05V-263

Safety Defect and Noncompliance Report Guide for Vehicles Part 573 Defect and Noncompliance Report

RECALL SERVICE BULLETIN

SUBJECT: Ametek NGI Air Pressure Dash Indicator Calibration

SIDE VIEW OF AIR SENDERS
FIG. 2-1

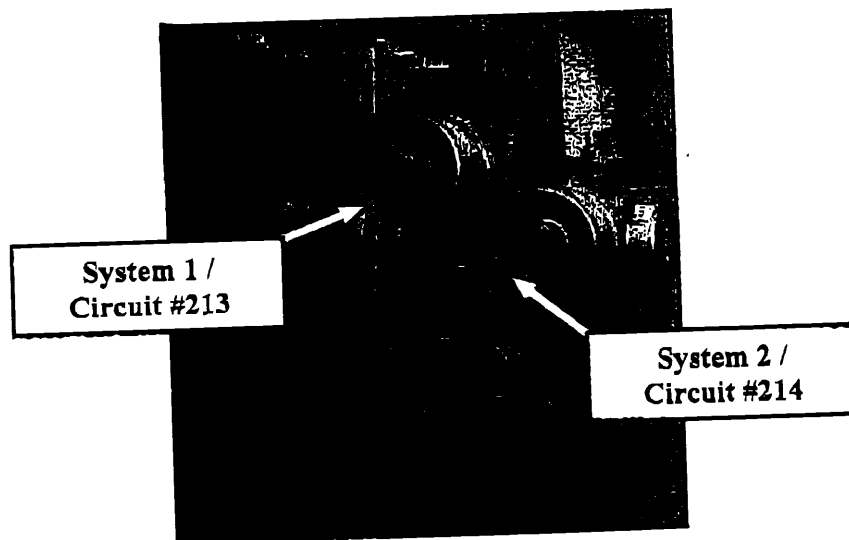
1. Observe all industry safety standards and secure vehicle to allow for disconnection of the air senders at to the front of the treadle assembly.

NOTE: Disconnect **ONLY ONE** sender at a time to ensure proper reconnection.

FRONT VIEW OF AIR SENDERS
FIG. 3-1

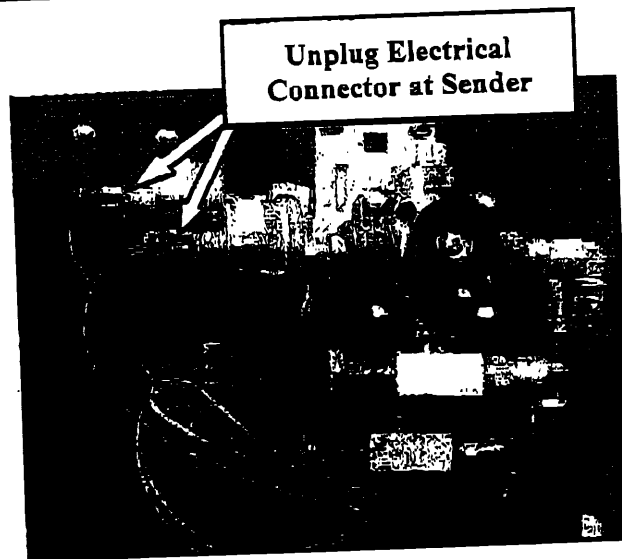
2. Refer to FIG. 3-1. Locate air senders at the front of the treadle assembly mounting plate.

NOTE: Disconnect **ONLY one** sender at a time to ensure proper reconnection.

3. Unplug electrical connector at one sender, plug one jumper harness from kit into the sender.
4. Plug electrical connector (previously unplugged from sender) into the jumper harness.
5. Repeat steps #3 and #4 for the remaining sender circuit.
6. Test the operation of the air pressure indicator in the dash.
